**Project:** Police Memorial and North Cove  
Marina Electrical Vault Resilience  
Project Construction Services  
(November 2015)

**RE:** Addendum # 4  
**# of Pages:** 3 pages

A-103.00

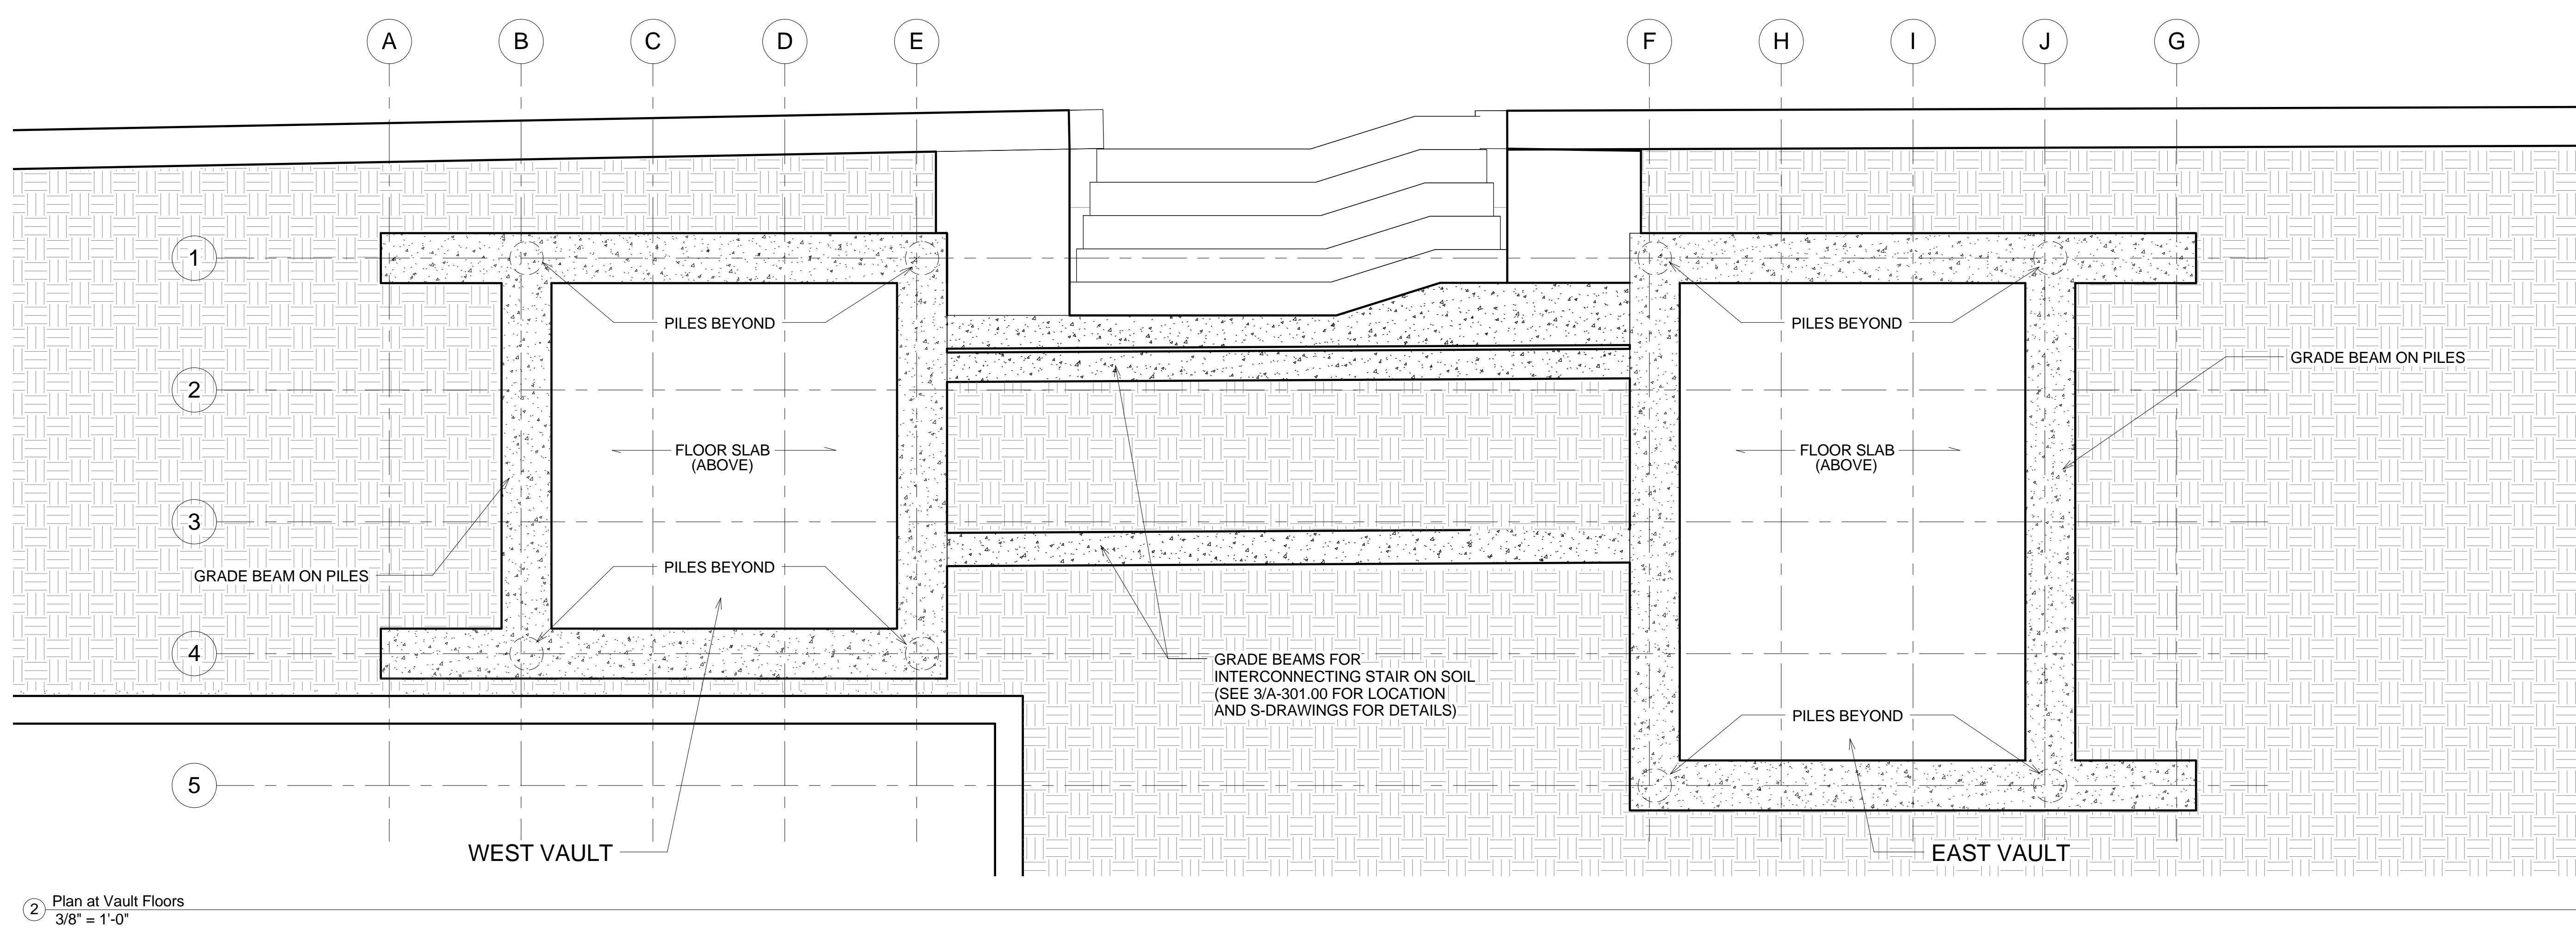
1. Architectural drawings A103 and A301 are hereby revised and attached. The notation referencing “cedar glulam girders” has been revised reflect “3 ½” x 7” glulam girders.”
